CITY OF FISHERS AGENDA

BOARD/COMMISSION: Planned Unit Development (PUD) Committee Meeting
DATE: 10/4/2023, at 5:00 PM
DIRECTIONS: Launch Fishers Theater , 12175 Visionary Way, Fishers, IN 46038

b. **Parkside Self Storage**
   Parcel: 15-11-30-00-00-023.019
   Case: PUD-23-5
   Request: Request to approve architecture for a new self-storage facility known as Parkside Self Storage. Subject site is located at the address 12915 Parkside Dr.
   Petitioner: Nick Schultz (nschultz@structurepoint.com)
   Planner: Bre King, Senior Planner (kingb@fishers.in.us)

Planned Unit Development (PUD) Committee
Staff Report

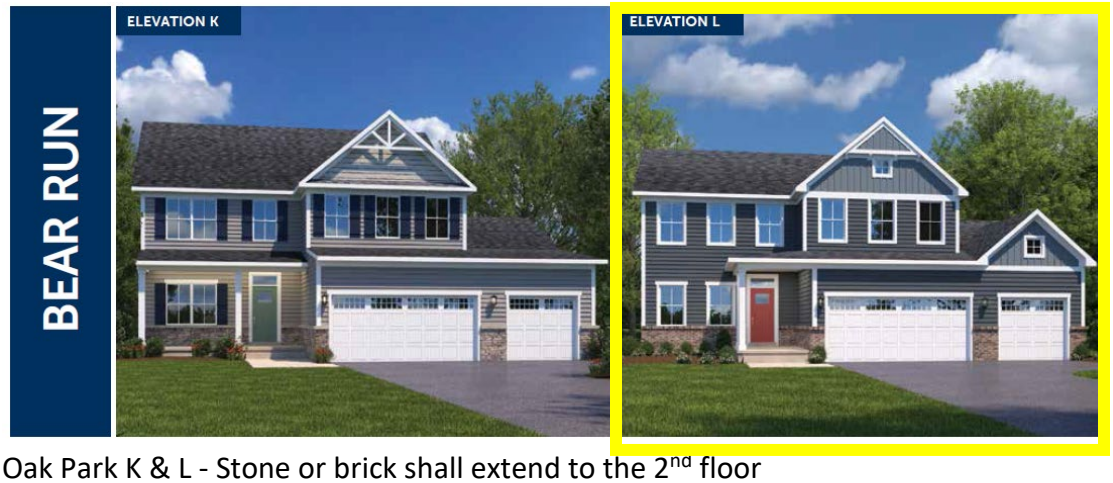
- Bear Run K & L – Extend porch on L or remove

- Oak Park K & L - Stone or brick shall extend to the 2nd floor

- Seneca K & L - Stone or brick shall extend to the 2nd floor
